FOR CONTRACT NO.: 12-0G9404

**Aerially Deposited Lead Investigation Report,
I-5 Soundwalls at El Camino Real,
San Clemente, California
June 6, 2008**

**Foundation Report for Proposed Soundwall Nos. 83,93,55-203 and 101 on
Soundbound Interstate 5 near El Camino Real, City of San Clemente, California
September 23, 2008**

**Materials Report For Proposed Soundwalls
On Southbound Interstate 5 Near El Camino Real,
City of San Clemente, California
December 3, 2008**

FIGURE 2 (SHEET 1 OF 9)

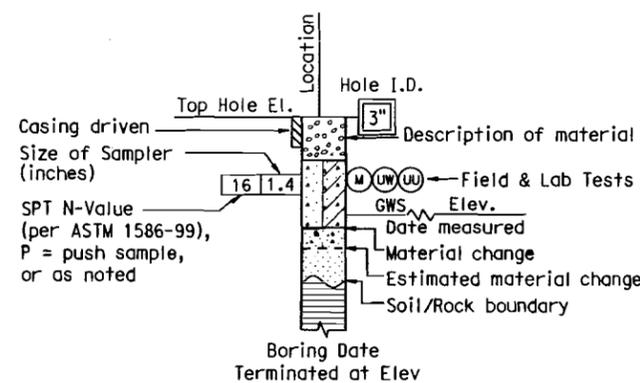
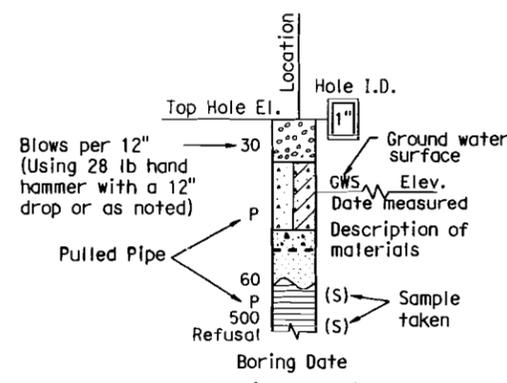
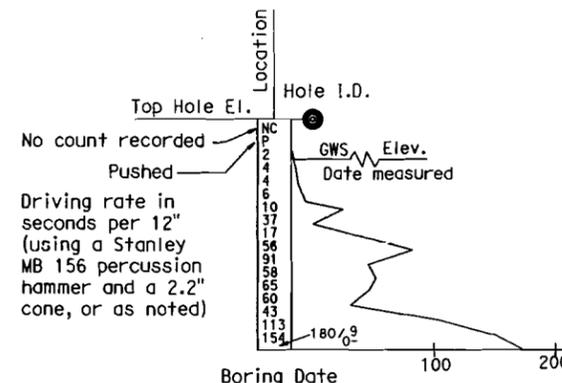
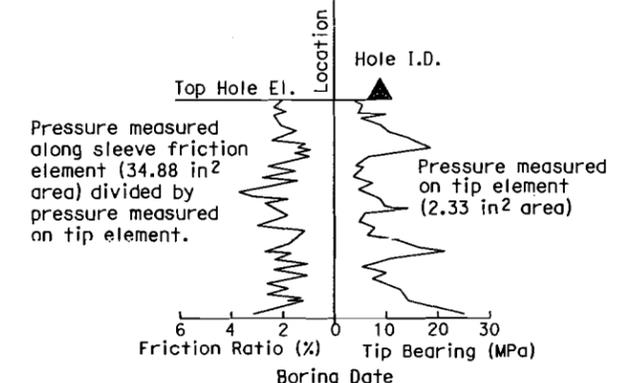
| LINE NO. | REPORT PAGE NO. | CALTRANS REVIEWER | COMMENTS | RESPONSE |
|----------|-----------------|-------------------|---|---|
| 7 | Figure 2 LOTB | Jie Huang | For the Logs of Test Borings (Sheet 3 to 6 of Figure 2), please correct the soil description and soil consistency. These must | As indicated in our LOTB, blow count of 61 shown on LB-1 is from California ring sampler, not SPT sampler. As such, |

| LINE NO. | REPORT PAGE NO. | CALTRANS REVIEWER | COMMENTS | RESPONSE |
|----------|-----------------------------|-------------------|---|--|
| | | | <p>conform to the Soil and Rock Logging, Classification, and Presentation Manual (Caltrans, 2007), especially Section 2.4. For example in LOTB of LB-1, the top layer of SPT blow count 61 is described as "dense". However, according to Caltrans' manual, it should be described as "very dense".</p> <p>In LOTB5 of LB-5, "firm" is used to describe the consistency of clay, however, according to the manual "medium stiff" should be used.</p> <p>Bench mark information should be used on the LOTBs per Pg 55 of the manual.</p> | <p>the consistency of "dense" is correct.</p> <p>We will revise our LOTB to incorporate this.</p> <p>The bench mark information is now available and we will include that on our LOTB.</p> |
